# **STAFF REPORT**

Planning Commission Meeting: March 25, 2019

Application: RZ19-0002: Zoning amendment for RP-3 District (The Villas of

Asbury)

# Attachment A SITE PLAN FOR ZONING AMENDMENT

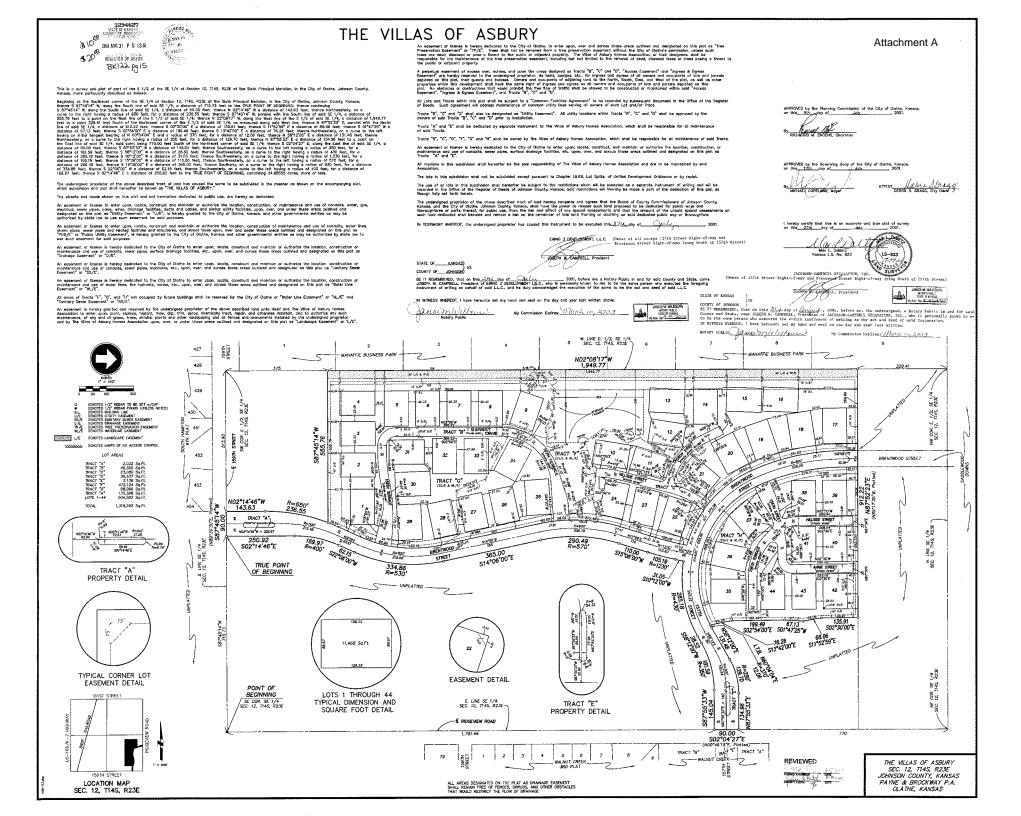
The 4-plexes within the development are individually platted and when Lots 15 and 16 were platted in 2001, they were located over the setback line. Staff met with the applicant to discuss alternative solutions such as reorienting the lots or building smaller 4-plexes so that the buildings don't encroach into the setback.

Since those options were not possible, the applicant is proposing to reduce the 75-foot setback immediately west of Lots 15 and 16. The new setback line would range from 65 to 71 feet. The rest of the setback line would remain at 75 feet. An exhibit of the

The applicant is requesting a waiver to this requirement since the setback is proposed to range from 65 feet to 71 feet immediately west of the Lots 15 and 16.

The applicant states that existing hedgerows will continue to provide a buffer between this development and the industrial properties to the west. The hedgerow will not be affected by this proposal and additional trees will be planted for additional screening. The proposed site plan shows evergreen trees on the west property line to provide an additional landscape buffer. Also, the public will suffer no loss or inconvenience by the granting of the waiver.

- (1) An amendment shall be granted for the RP-3 zoning ordinance to allow a reduced building setback of 65 feet from the west property line as shown on the submitted site plan.

- (2) A waiver shall be granted to permit the landscape buffer along the west property line to range from 65 feet to 71 feet as shown on the submitted site plan.

- (3) Prior to obtaining building permits, the property shall be replatted to show the adjusted building setback line.
  - (4) A landscape plan showing the size and type of trees to be planted along the west property line shall be submitted and approved with the building permits.
